OHIO TURNPIKE AND  
INFRASTRUCTURE COMMISSION

ADDENDUM NO. 2

PROJECT NO. 59-17-02  
REPAIRS AND RESURFACING  
EASTBOUND AND WESTBOUND ROADWAYS  
MILEPOST 136.00 TO MILEPOST 144.10  
ERIE AND LORAIN, OHIO

QUESTIONS AND ANSWERS THROUGH 1:00PM ON JANUARY 23, 2017

TCB-3

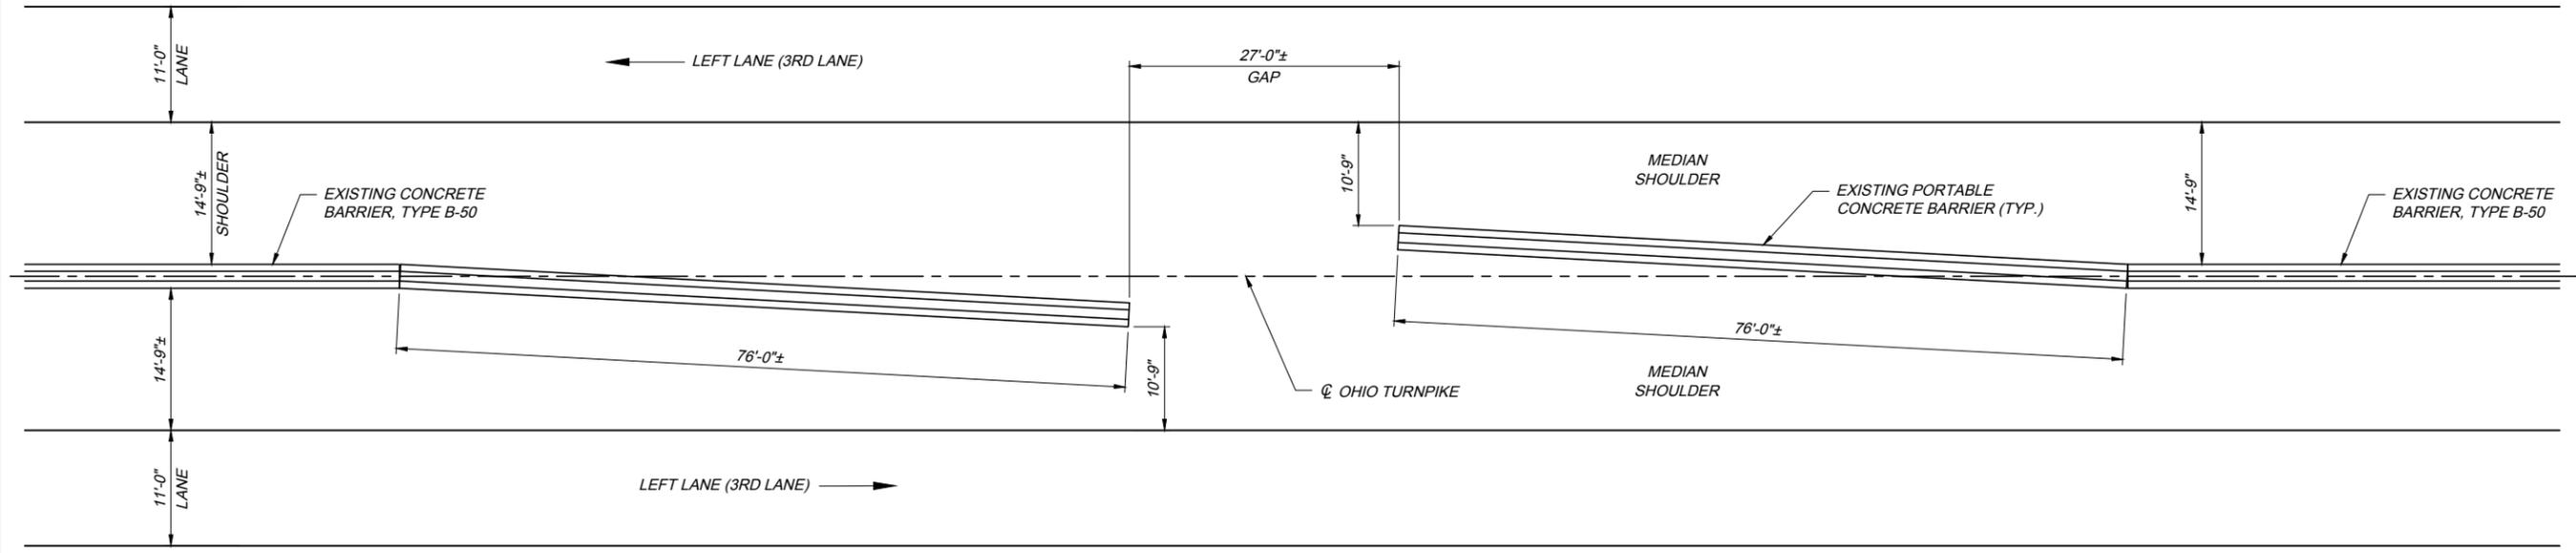
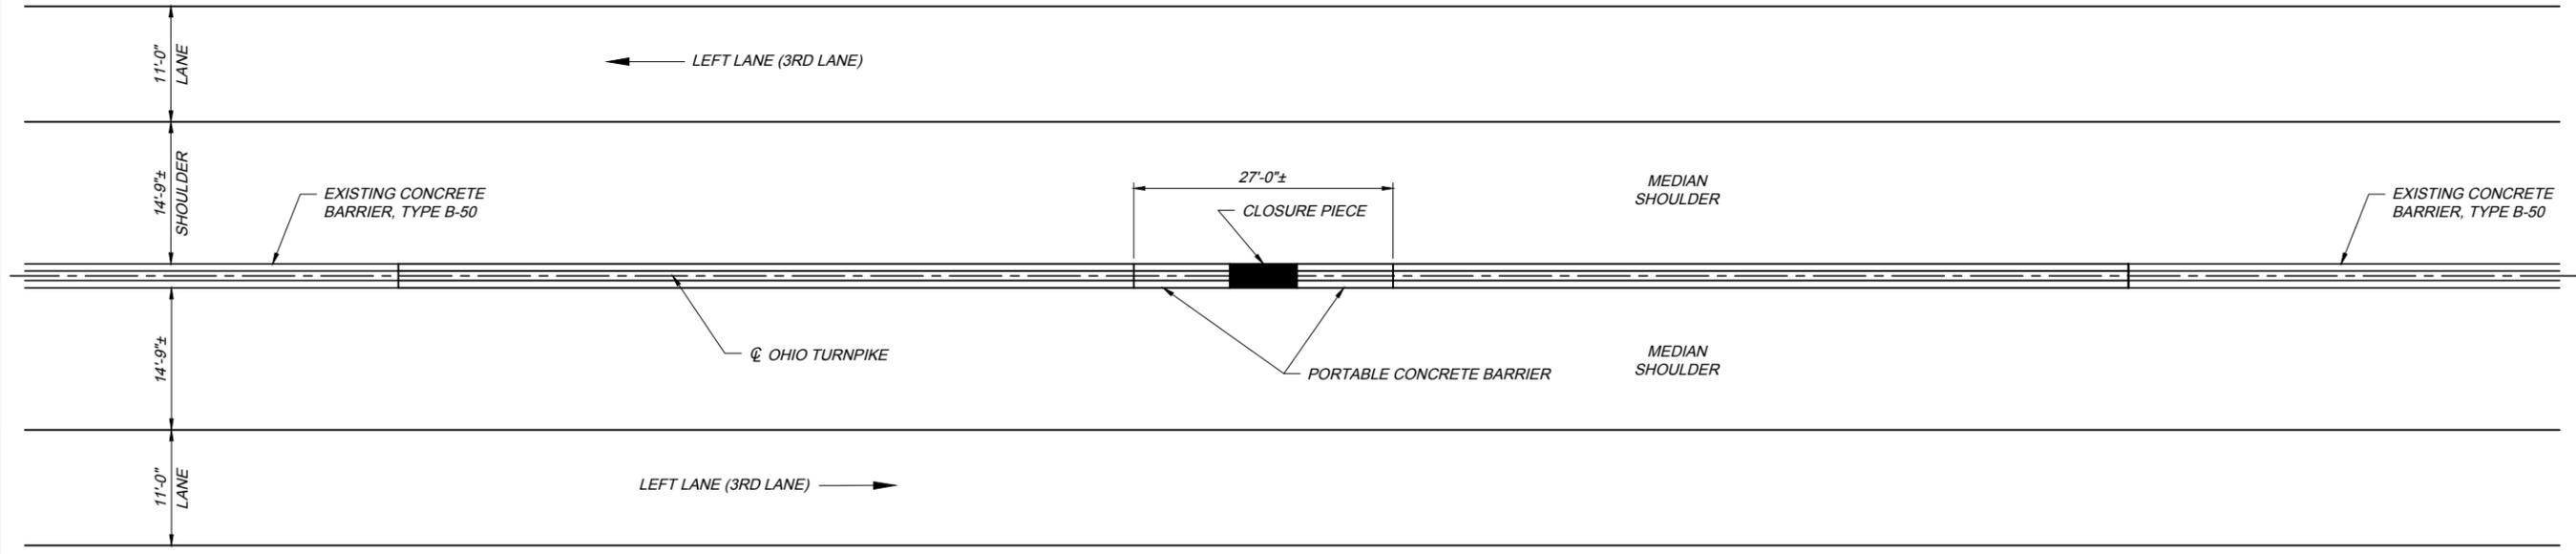
**Q#8 Can OTC Std Drawing TCB-3 be added to the Bid Express Plans?**

**Q#10 Once the seven crossovers are closed (for Stage 1 (A)), does the asphalt under the portable concrete barrier get mill and fill 2.0" or is the intent to mill/fill adjacent to the PCB?**

*A#8 Yes, the standard drawing is furnished with this Addendum No. 2.*

*A#10 The Contractor shall plan its operations such that the median crossovers are milled and paved along with the median shoulder during the normal progression of work. Adjustments to the temporary portable barrier, in order to accomplish this work, shall be included in the unit bid price for ITEM SPECIAL – EXISTING CROSSOVER TO BE CLOSED/RE-OPENED, AS PER PLAN. Any barrier vehicles required for this operation shall be considered incidental to Item SP 614.*
